From: David Werts <david.werts@comcast.net>
Sent: Friday, June 30, 2023 1:13 PM
To: Jim Spung; 'Rolland Lee'
Cc: Wayne Harper
Subject: RE: File #16C23 - Legacy Plaza CUP/Site Plan Amendment - Review Comments 06-21-2023 Response #2

From: Jim Spung <jspung@taylorsvilleut.gov>
Sent: Wednesday, June 21, 2023 9:03 AM
To: 'Rolland Lee' <rollandtlee5335@gmail.com>; David Werts <david.werts@comcast.net>
Subject: File #16C23 - Legacy Plaza CUP/Site Plan Amendment - Review Comments 06-21-2023

This transmittal contains City and review agency comments for the proposed CUP/Site Plan Amendments for Legacy Plaza at approximately 1758 W. 5400 S. in Taylorsville, Utah. Please contact the individual reviewer directly with any questions you have.

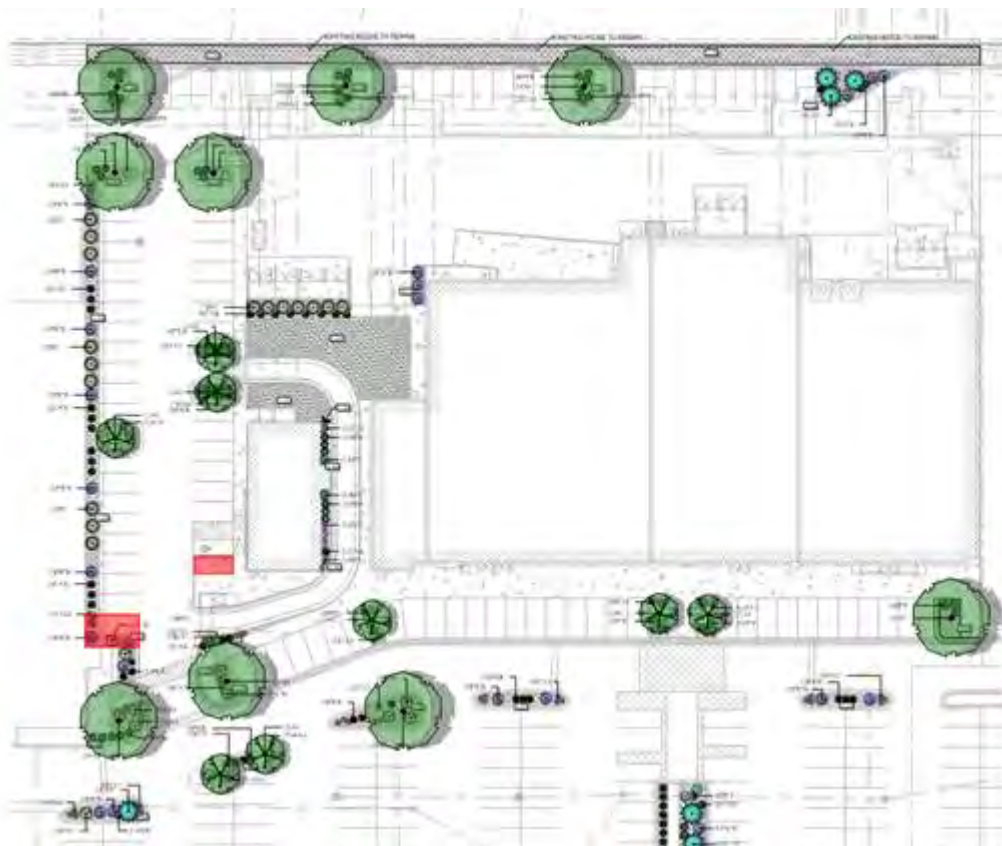
4. Fire Hydrant may need to be added or moved to reach FDC. **Look forward to review, there are currently 2 fire hydrants on the north end of this parcel. One north of the future Chipotle Building and other north of the future ULTA space.**
5. If an exterior door does not enter directly to fire riser a PIV will be required. **Noted.**

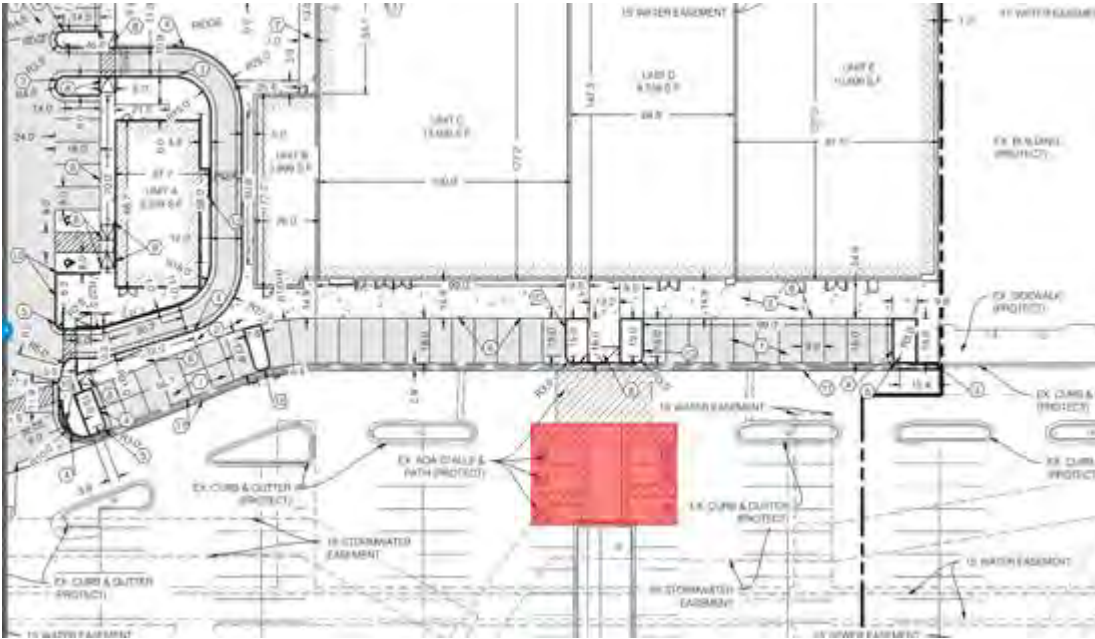
- Our building official is out this week, but I believe the IBC will require that any ADA stalls provided be located as close as possible to the entrances they serve. With the addition of the nose-in parking in front of the buildings, it is likely you will be required to designate some of those stalls as ADA compliant rather than the existing ADA stalls currently marked across the drive aisle. **The revised site plan added 4 ADA stalls in the nose in parking spaces. Two ADA spaces are to the east in front of Five Below and ULTA, and two ADA spaces are to the West in front of Chipotle and new retail shops.**
